MODIFICATION REQUEST:
Cardinal Freeman Retirement Village
Concept Plan & Project Approval

MP08_0245 MOD 1
MP08_0260 MOD 1

Director-General's
Environmental Assessment Report
Section 75W of the
Environmental Planning and Assessment Act 1979

April 2013

Figure 6: Proposed modified Concept Plan layout
(Base image source: proponent's Environmental Assessment)

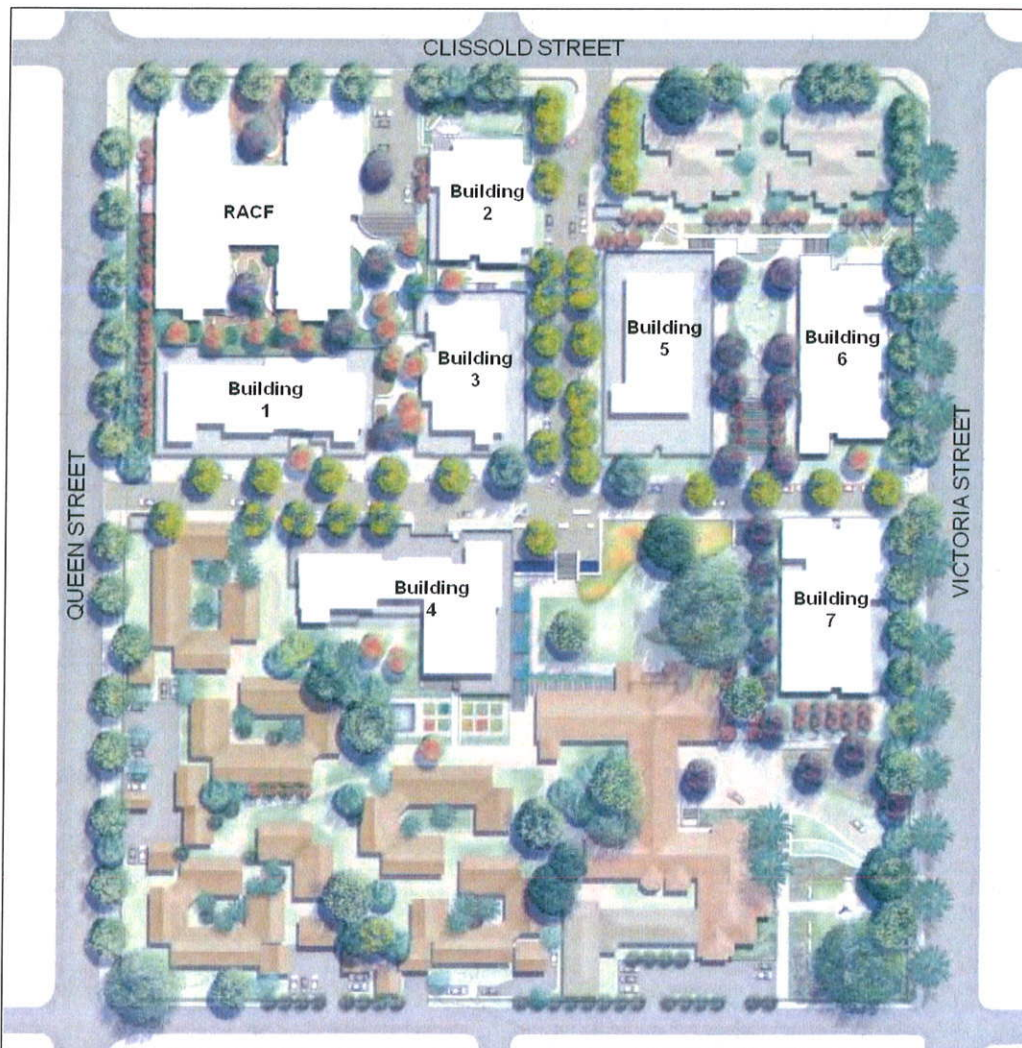
There is an existing east-west road that curves through the site between Victoria Road and Queen Street (**Figure 3**). The approved Concept Plan alters the road layout by straightening the eastern half of the road and realigning the western half, while generally maintaining its curved layout (**Figures 4 and 5**). The proponent is now seeking to realign this through road so that it is completely straight along an east-west axis (**Figure 6**).

A public submission has raised concern that the proposed straightened road will form a 'rat-run', encouraged by the creation of a visual link between Victoria and Queen Streets.

The Department agrees that the proposal improves the setting of the historic items through the improved village green layout and enlarged unobstructed forecourt to Glentworth House. These improvements would allow for a better appreciation of the heritage items by residents and the wider community. The alteration to vehicle and pedestrian legibility of the site is also beneficial.

The Department notes that an east-west road has existed on this site since the commencement of its use as a retirement village in the mid 1970's. The proposal is not creating a new link road, instead just realigning and existing one. The Department acknowledges that the straightened road may create a visual link between Victoria and Queen Streets. However, given that the east-west road meets the middle of both Victoria and Queen Streets, does not connect to a defined destination, or allow a by-pass of an existing busy road it is not considered that the straightening of this existing road would result in a 'rat-run'. Furthermore, the proposed realignment reinforces the grid-like street pattern character of the local area and will allow an improved integration of the Village into the local area. The Department considers that the realignment of the road would not have a material impact on pedestrian or driver safety. It is noted that council and Roads and Maritime Services do not object to the realignment of the central east-west road.

Figure 7: Comparison between approved building heights (left) and modified building heights (right)
(Base image source: proponent's Environmental Assessment)

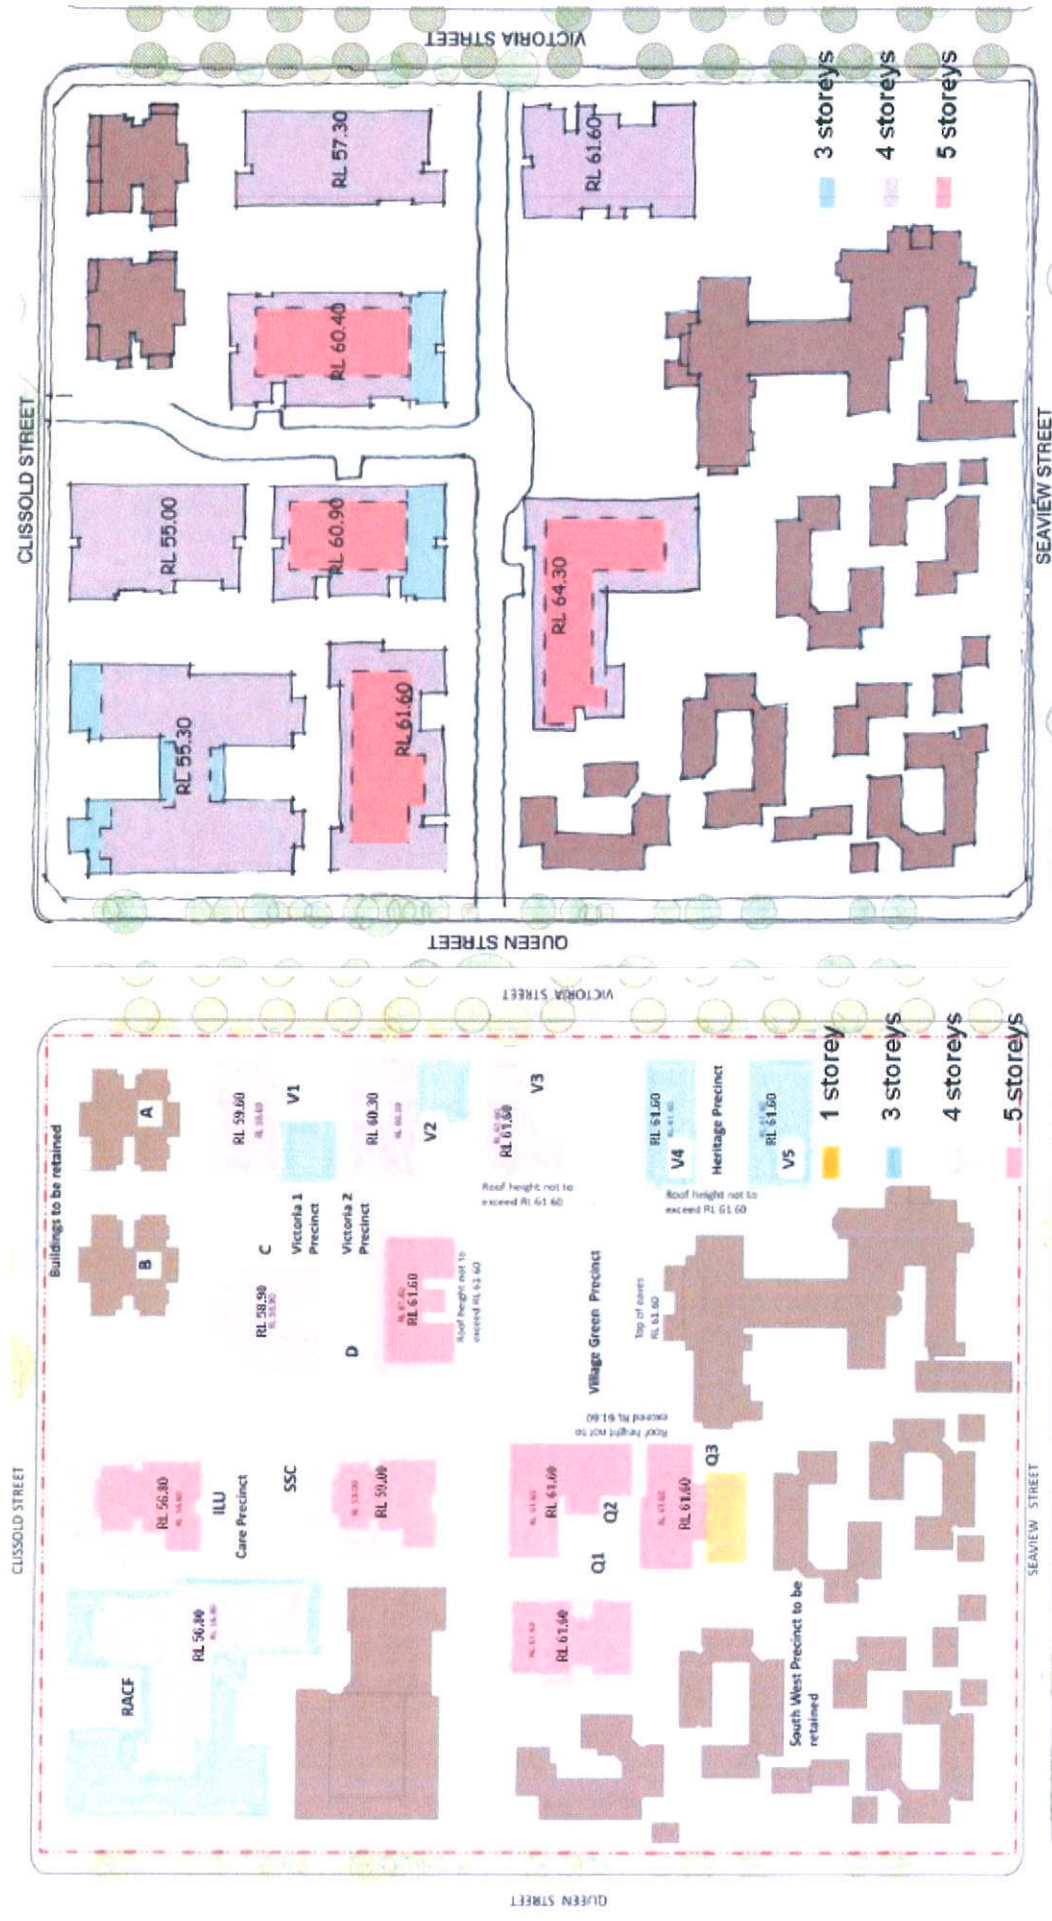
Residents have objected to the inclusion of 5 storey building heights generally and the impact on Queen Street. The approval restricted overall building heights to being no taller than RL 61.60 (excluding rooftop plant/structure) so that no part of the development would rise above the eaves line of the two heritage items on the site. A comparison of the approved and modified building heights is provided at **Figure 7**. There are four buildings with a proposed building height of 5 storeys:

Of the four 5 storey buildings proposed, only one building, Building 4 (equating to an RL of 64.30), would rise above the eaves line of the heritage items (RL 61.60).

Buildings B3 and B5 are derived from the consolidation of buildings which, as approved, would have also been 5-storeys (refer to **Figure 7**). The Department notes that although the building envelopes have changed, that the modifications are minor in nature and would not have a significant impact on residential amenity.

The resident suggests that proposed Building 5 would block her view of the heritage precinct. The Department notes that the approval shows Buildings C and D (part 4/5-storeys, **Figure 7**) already largely obscures the heritage precinct from Building B. Proposed Building 5 consolidates buildings C and D into one building envelope and the new B5 envelope is of a similar width as buildings C and D. The Department considers that due to the location, height and width of Building 5, the modification would not result in further obstruction of the heritage precinct from the objector's property at retained building B.

Figure 8: Comparison between approved staging plan (left) and modified staging plan (right)
(Source: proponent's Environmental Assessment and original approval)

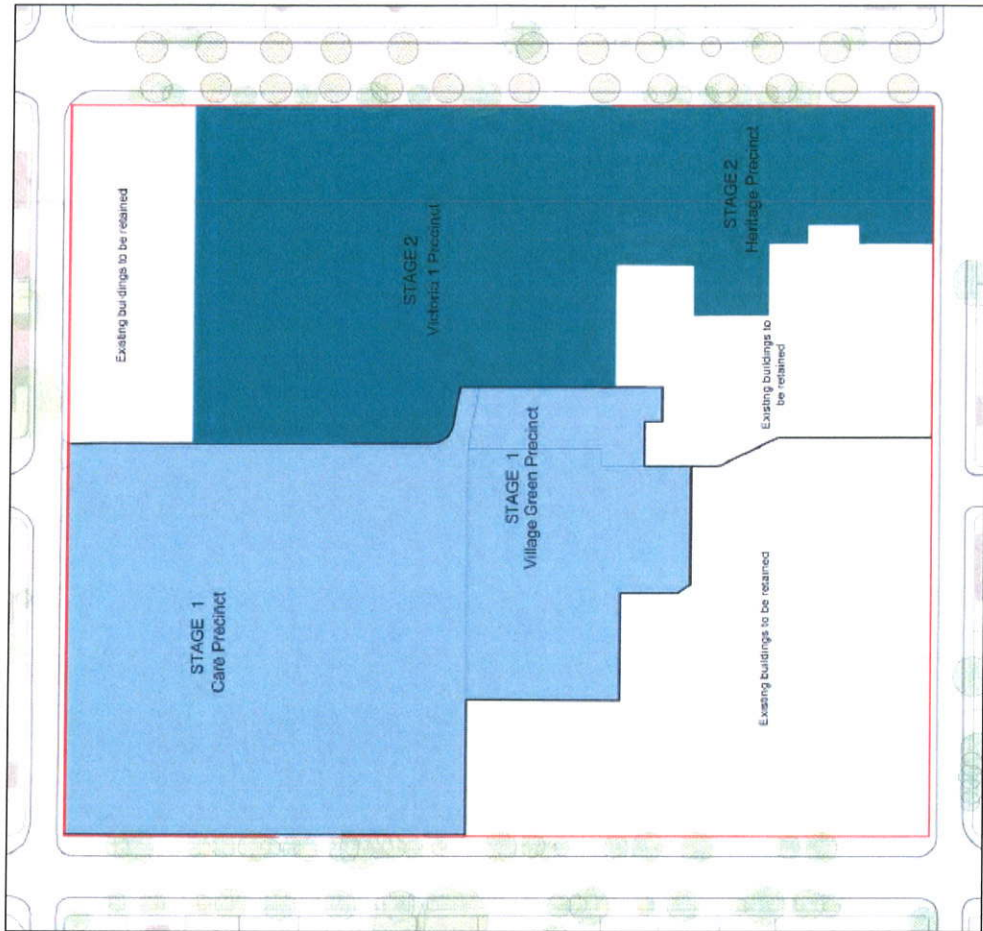
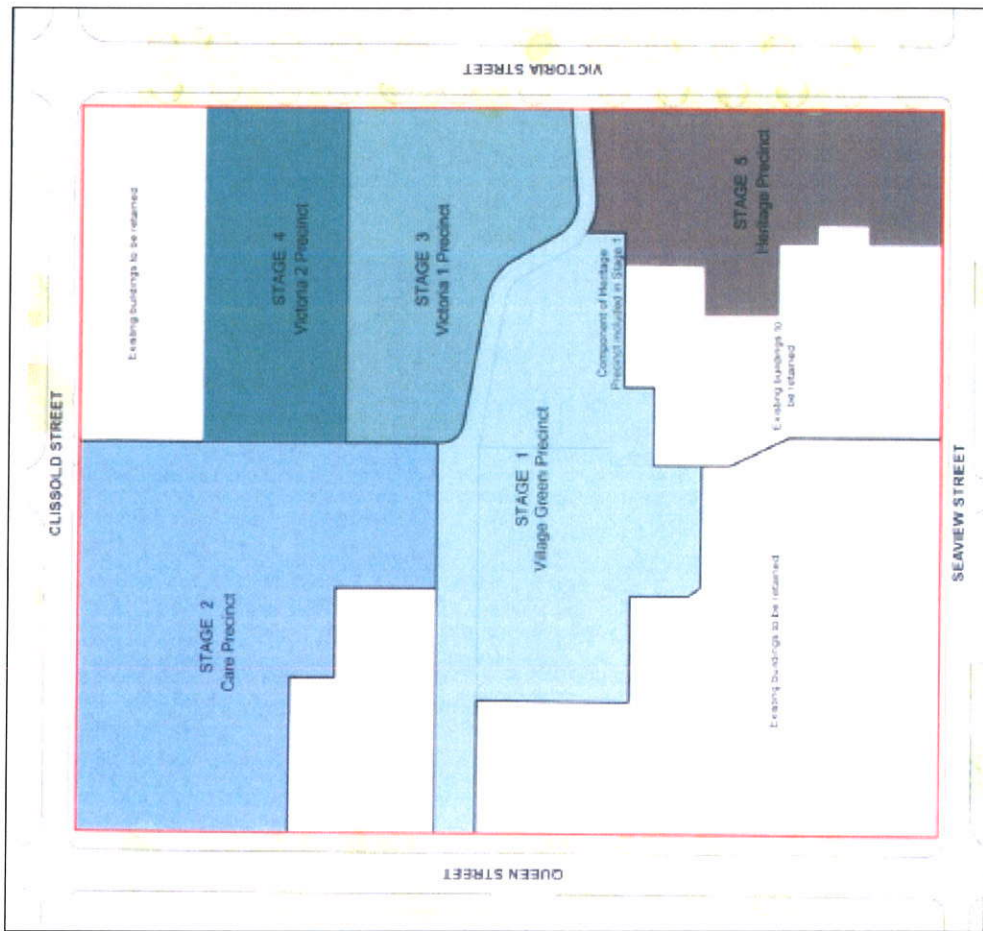
The proposal seeks to reduce the number of construction stages from five to two (Refer **Figure 8**), which will reduce the overall construction timeframe from approximately five to three years. The proponent has stated that this change is in response to residents' wishes for a swift delivery of the development with minimal impact on existing residents and services.

The Department supports the proposed reduced construction timeframe and consolidation of 5 development stages into 2. Further the construction of the Residential Aged Care Facility as part of the first phase of Stage 1 is also supported by existing Village residents. It is recommended that the conditions imposed on the Concept Plan be amended to reflect the revised staging arrangements.

Figure 9: Proposed modified Project Application layout
(Base image source: proponent's Environmental Assessment)

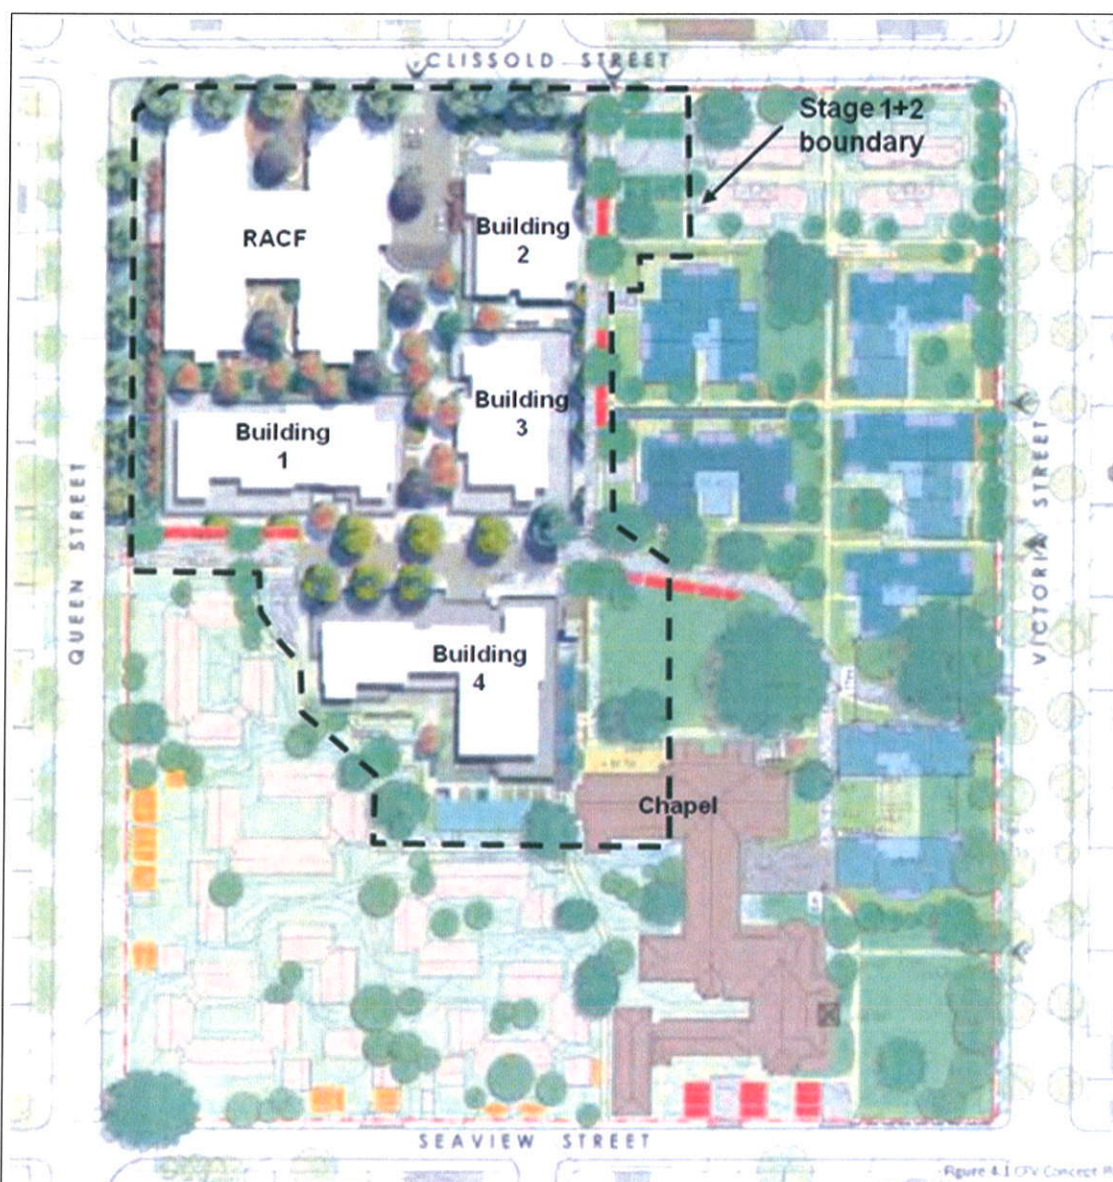
The proposed amendments to the Project Approval (MP 08_0260) issued for the first two stages include:

The Residential Aged Care Facility and Buildings 1, 2, 3 and 4 are located within Stage 1 and are subject to the Project Approval. A local resident has objected to the units not having adequate natural/cross ventilation. The Facility, by its nature, is required to have a functional layout dictated by its institutional use and specific needs of the health care facility with single rooms accessed off a central corridor. It would not be possible to cross-ventilate these rooms without a transformation of building design and future operational management. The Department does not consider that cross-ventilation can reasonably be expected in this circumstance and accepts that the Residential Aged Care Facility will require mechanical ventilation.

Buildings 1, 2, 3 and 4 comprise 141 Independent Living Units, of these Independent Living Units a total of 74 would be cross ventilated (52%). This figure falls 8% below the 60% rule of thumb advocated by the Residential Flat Design Code. Although the percentage of cross ventilated apartments is marginally below 60%, the Department notes that the units have been designed to meet the other standards of the Residential Flat Design Code in terms of room depths, kitchen ventilation, building layouts and passive solar design. On balance, the Department considers the marginal shortfall in cross ventilated units is acceptable in this instance.
